Petitions – Stop the Coundon Cycleway, and Support the Coundon Cycleway

APPENDIX A - SCHEME DETAILS

These drawings are Post-Consultation.
The notes on the plans highlight the changes
made from the consultation drawings.

Project: Air Quality Action Plan
Coundon Cycleway

Title: General Layout
Sheet 14 of 17

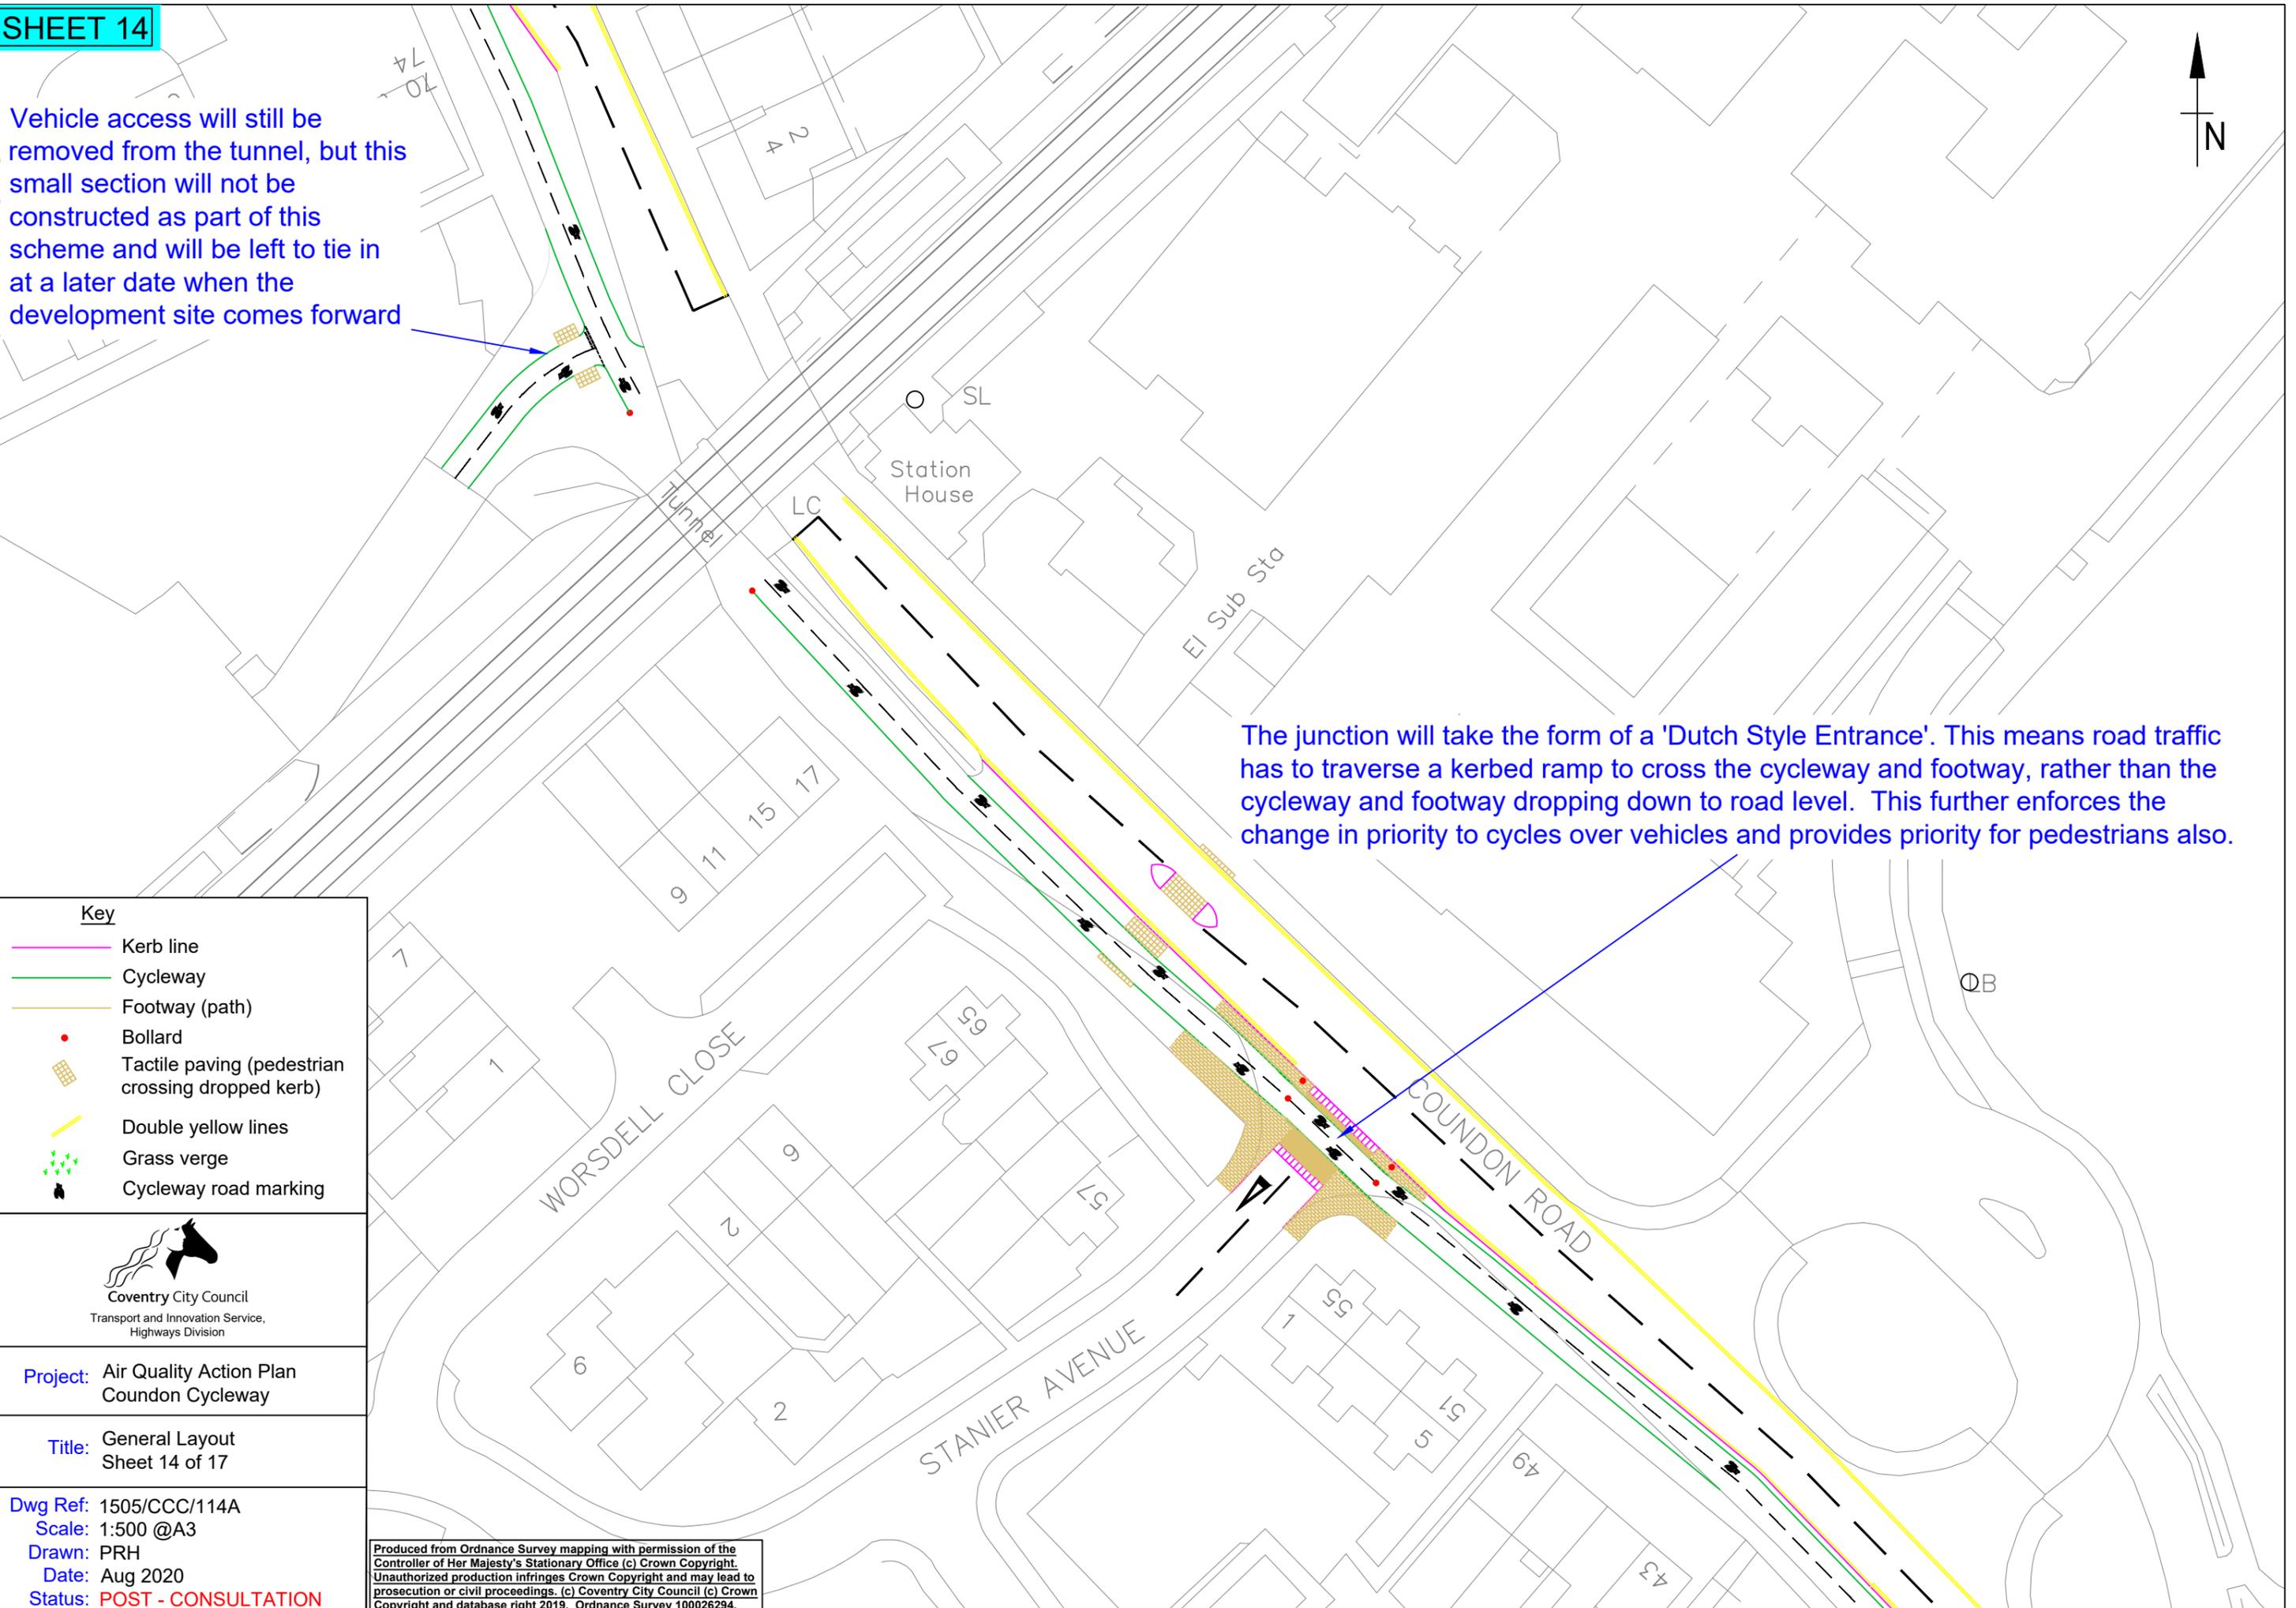
Vehicle access will still be removed from the tunnel, but this small section will not be constructed as part of this scheme and will be left to tie in at a later date when the development site comes forward

Title: General Layout
Sheet 15 of 17

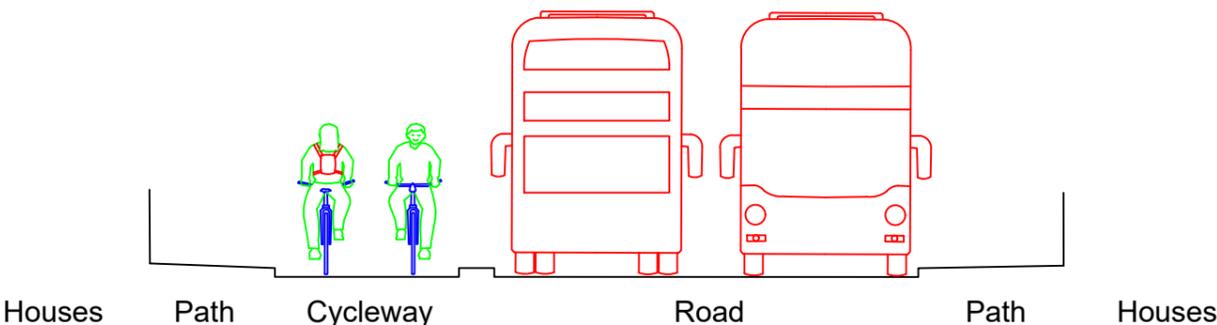
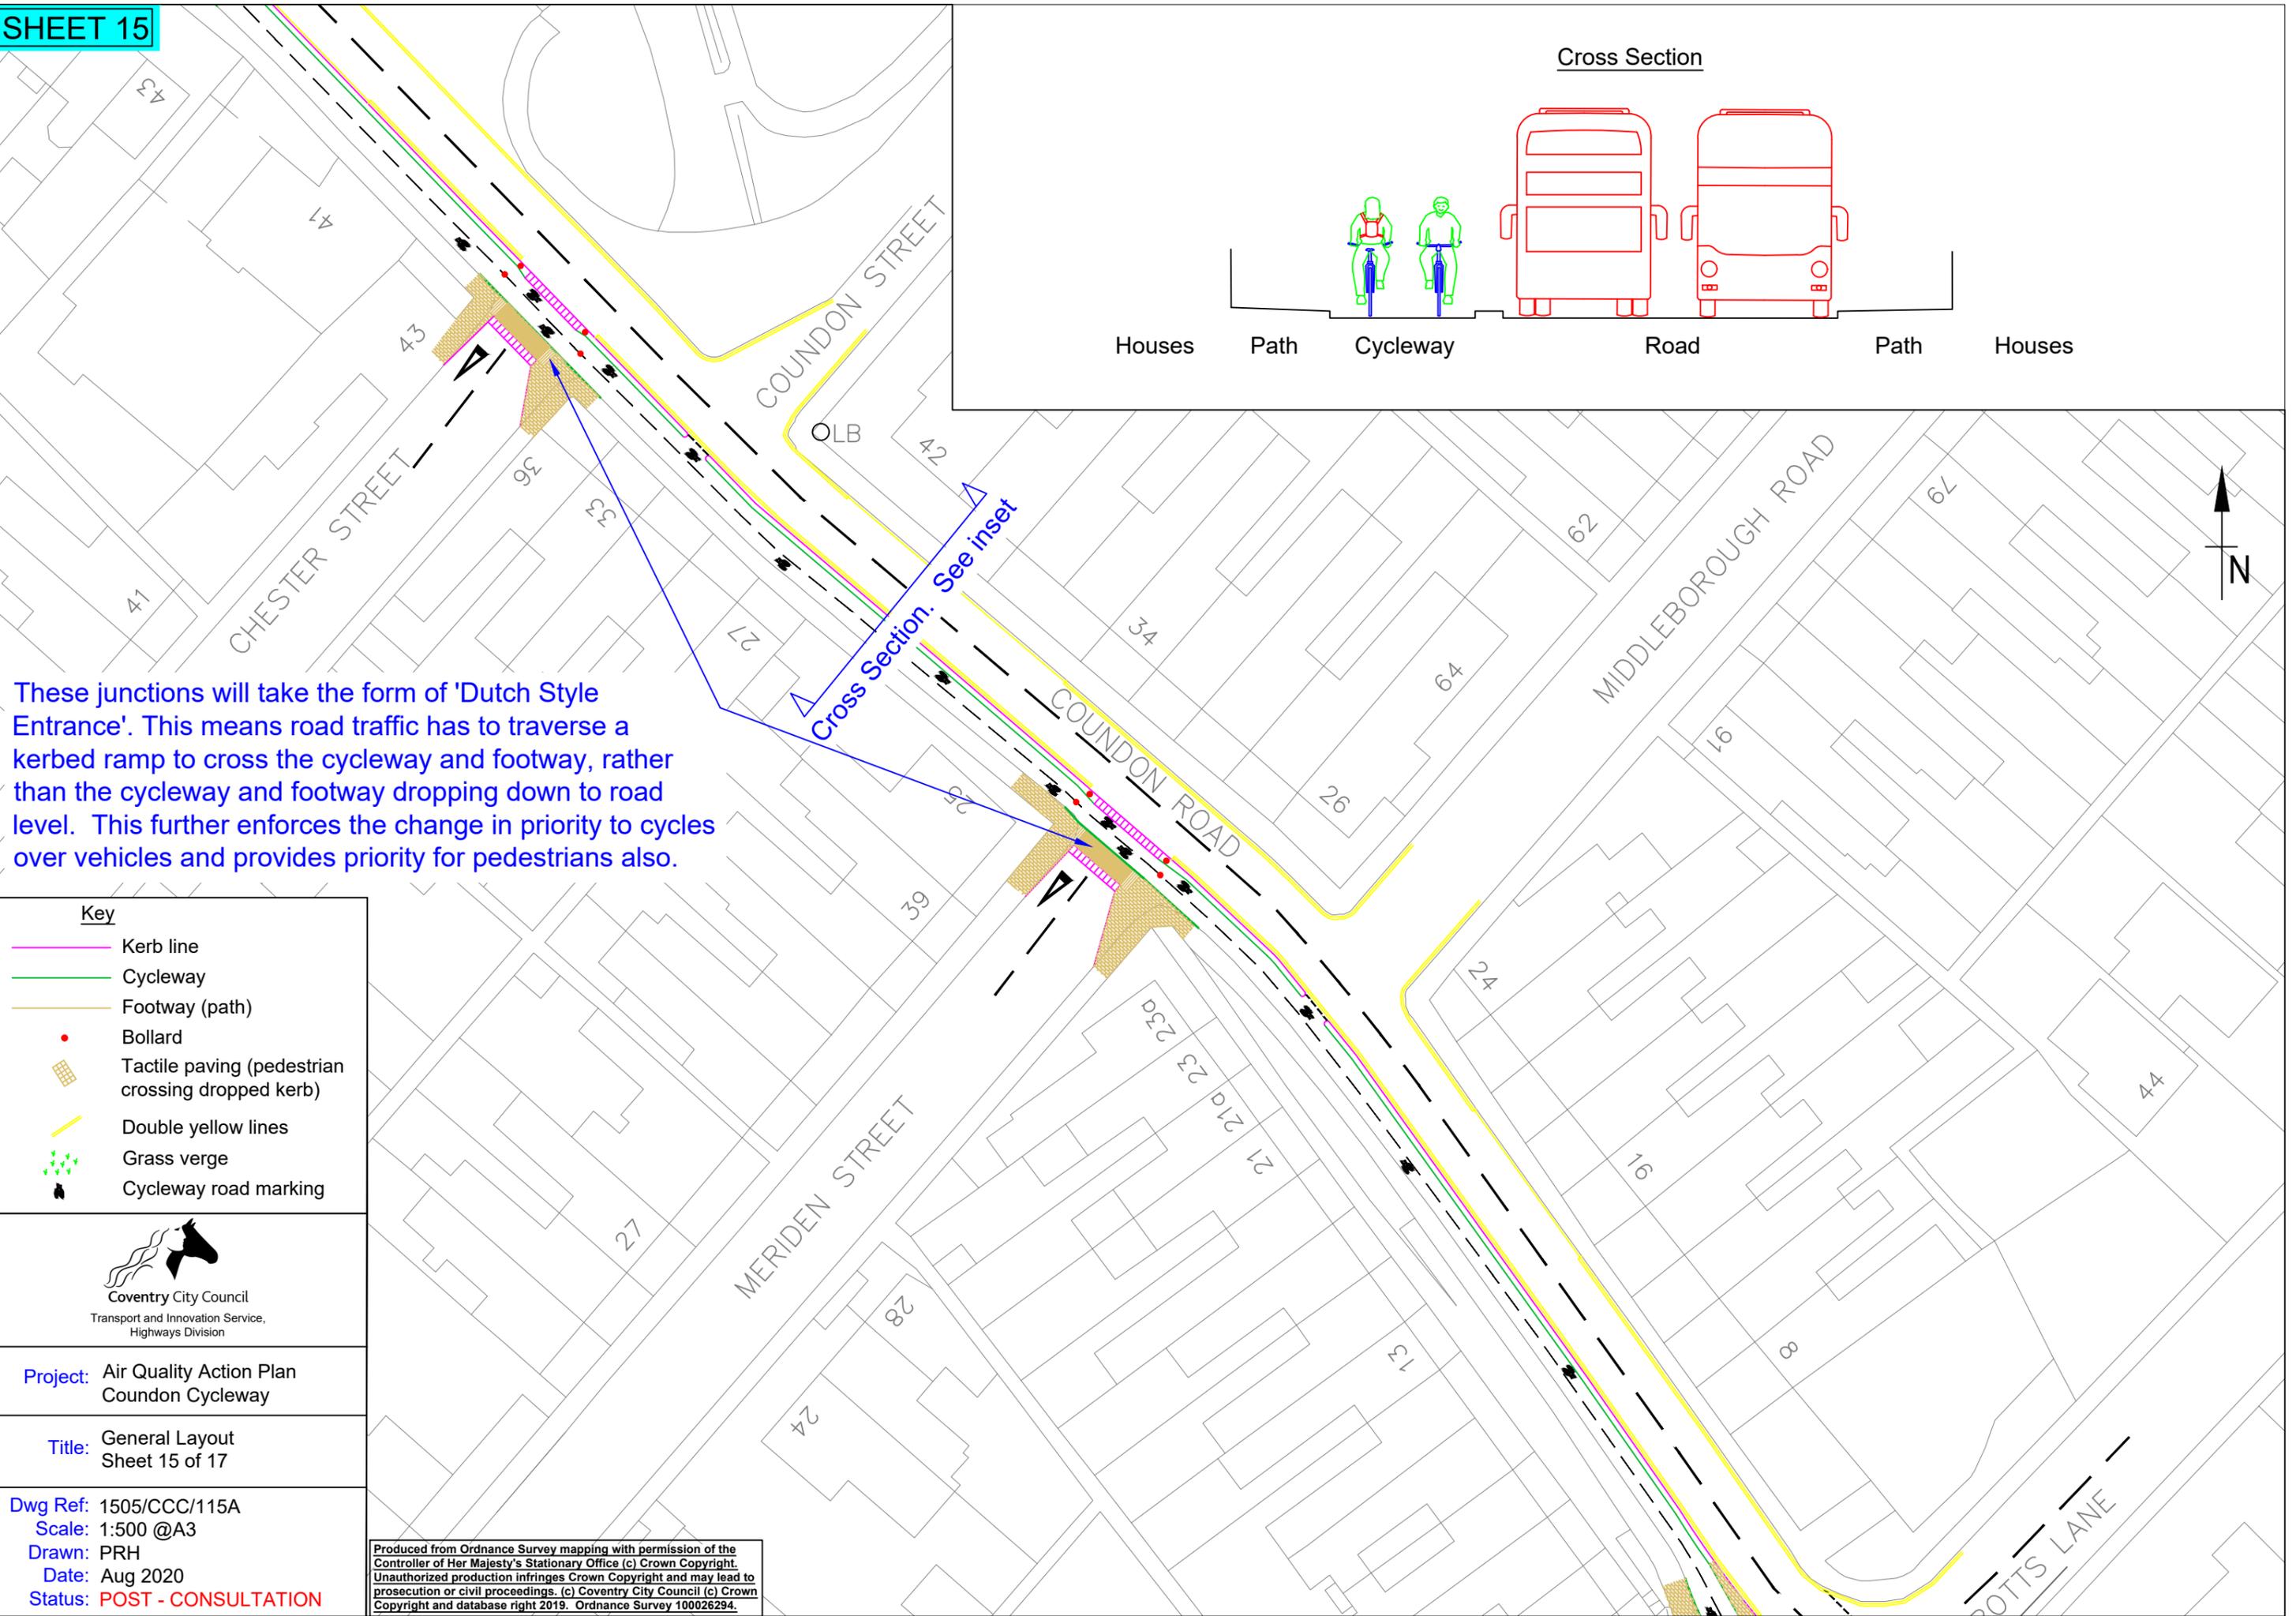
The junction will take the form of a 'Dutch Style Entrance'. This means road traffic has to traverse a kerbed ramp to cross the cycleway and footway, rather than the cycleway and footway dropping down to road level. This further enforces the change in priority to cycles over vehicles and provides priority for pedestrians also.

These junctions will take the form of 'Dutch Style Entrance'. This means road traffic has to traverse a kerbed ramp to cross the cycleway and footway, rather than the cycleway and footway dropping down to road level. This further enforces the change in priority to cycles over vehicles and provides priority for pedestrians also.
